Revised Cam Sprocket & Sensor For 2001-2005 GM 8.1L VIN G & E Engines

The AERA Technical Committee offers the following information regarding a revised cam sprocket sensor for 2001-2005 GM 8.1L VIN G & E engines. Depending on the year of vehicle manufacture, there are two distinct sprockets and sensors used for these engines.

2001-2003

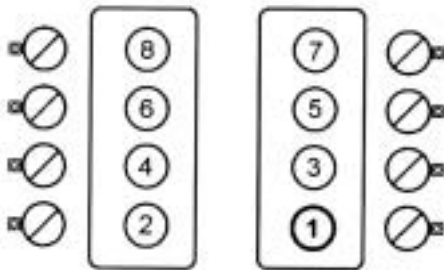
The camshaft sprocket and timing sensor were revised in 2002 to maximize the benefits of Magnetic Reluctance (MR) or “mirror image” ignition timing. The sprocket edge is now machined with a partial “quasi-mirror” polished edge rather than a contoured edge. To “read” the new edge, the cam sensor also required a change in the switching voltage.

The new polished edge allows the sensor to better measure movement and assures precise measurement for the life of the engine. MR is the most sophisticated timing system offered by GM. It allows the Powertrain Control Module (PCM) to push spark plug timing to the limit of efficiency without detonation, or engine knocking. This sensor retrofits back to the 2001 year engine.
